DEPARTMENT OF THE ARMY

28 March 2018

**SUBJECT: UST 750J Site Investigation Report
Request for Unrestricted Use, No Further Action Approval
Fort Monmouth, Monmouth County, Oceanport, New Jersey
PI G000000032**

PARSONS 401 Diamond Drive NW, Huntsville AL	Fort Monmouth New Jersey
BUILDING 750 AREA SOIL SAMPLE RESULTS FOR USTs 750F, 750H, 750I, AND 750J	
CREATED BY: RR	REVIEWED BY: KF
DATE: SEP. 2016	FIGURE NUMBER: FIGURE 4
PROJECT NUMBER: 748810-06031	FILE: FIGURE 4.mxd

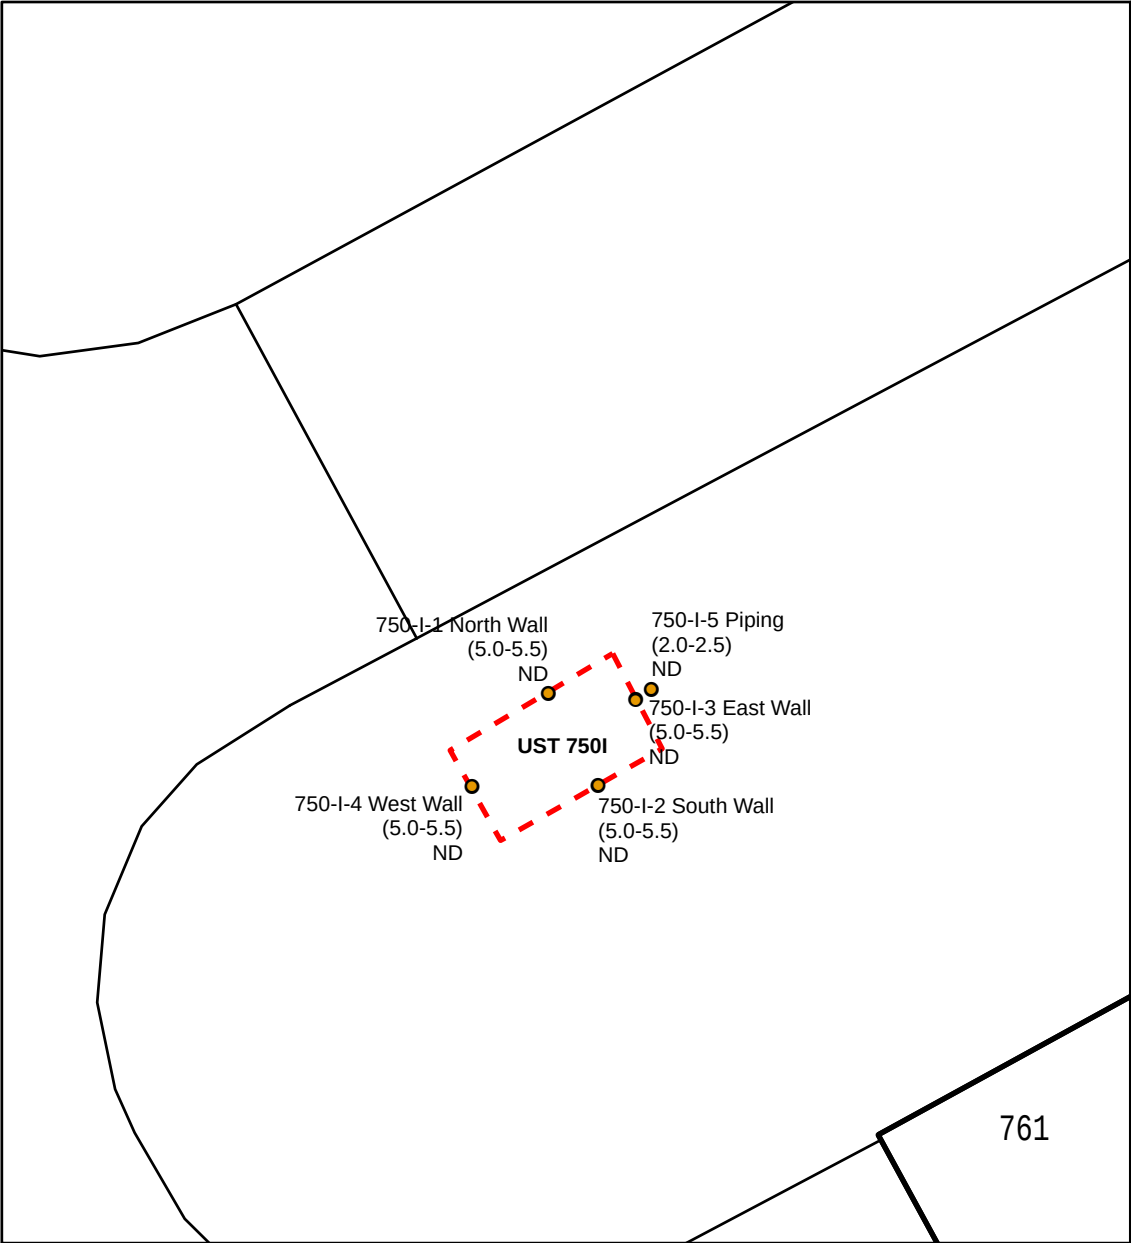
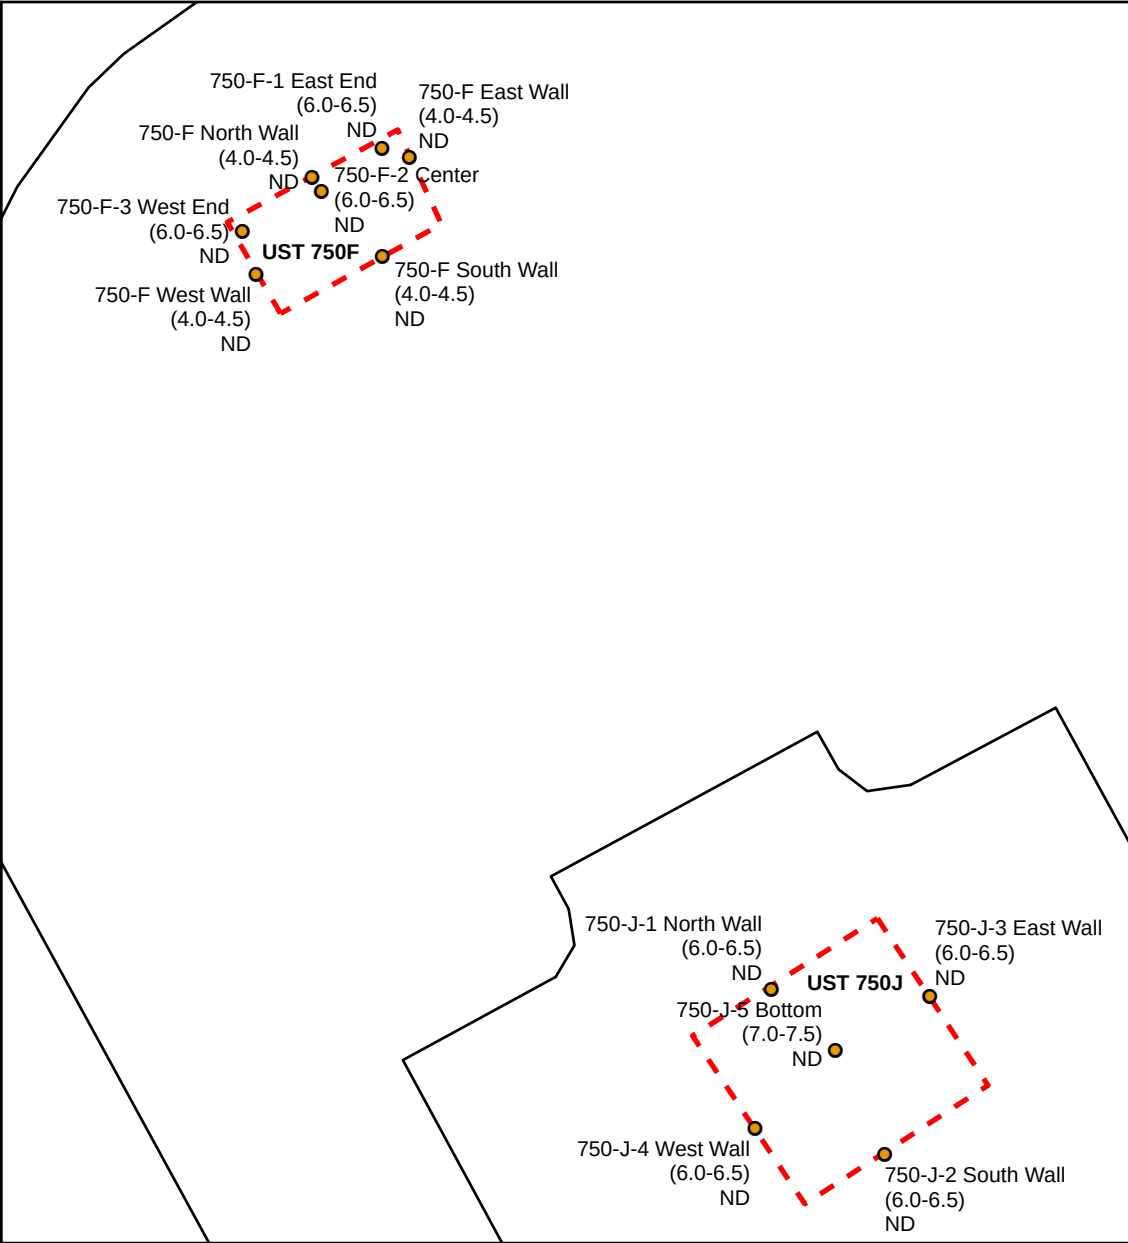
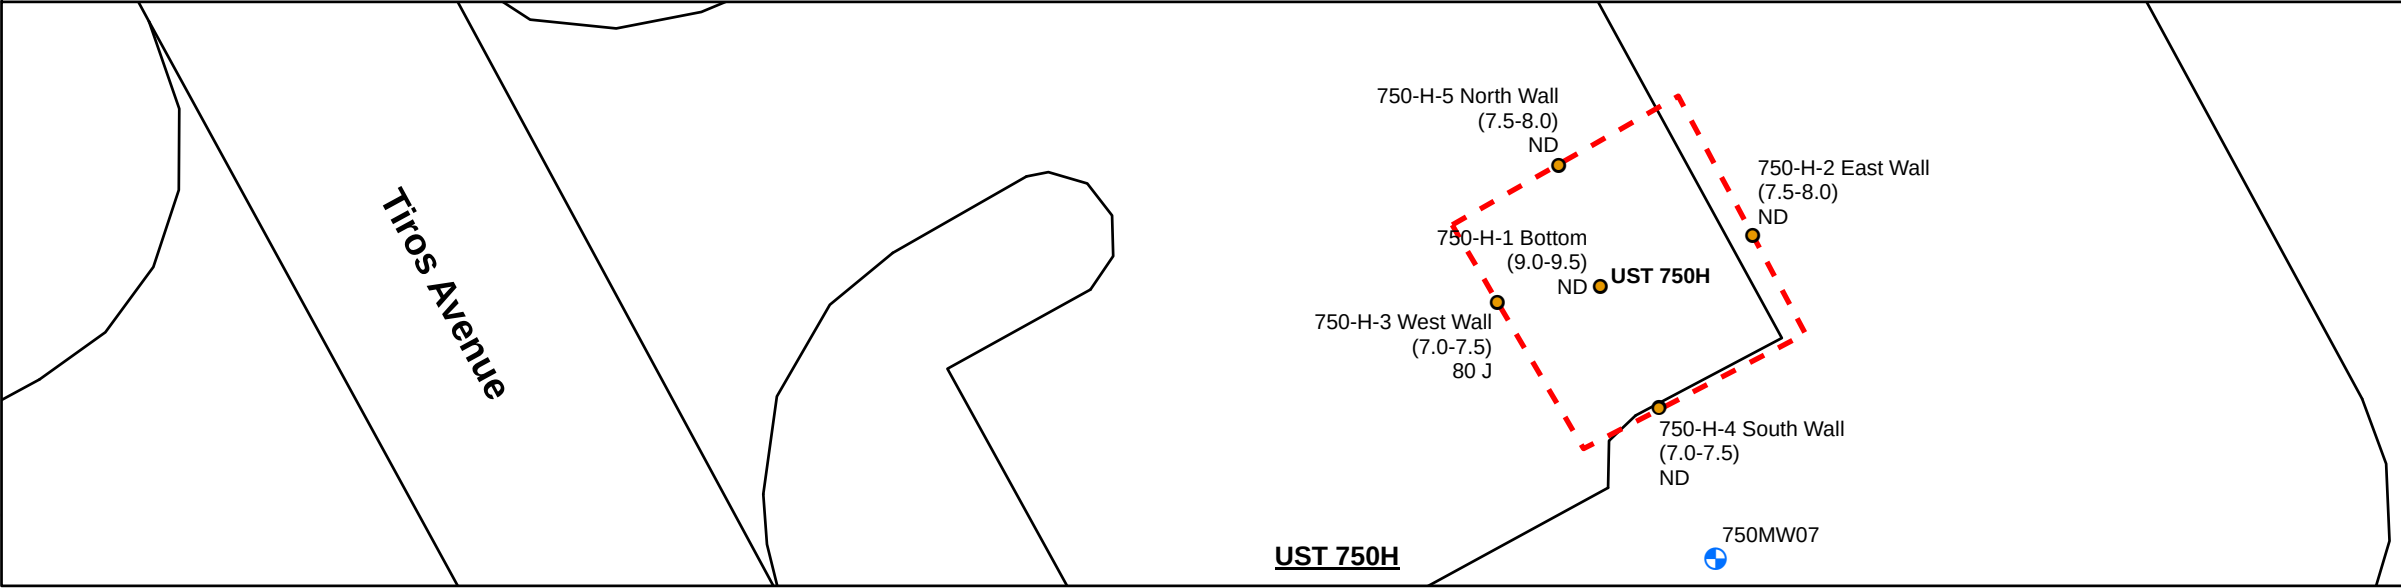
UST 750J – Anomaly P51_27 - #09-08-20-0915-22 – Soil was removed to within 2' of the ground water table, and a sheen was noted. As indicated in the original Army notes, a ground water investigation is warranted. Please submit a workplan for performance of same.

- UST 750J file review summary and analyses are presented in **Attachment M**, and soil sample locations and analyses are presented on Figure 4 of **Attachment B**.
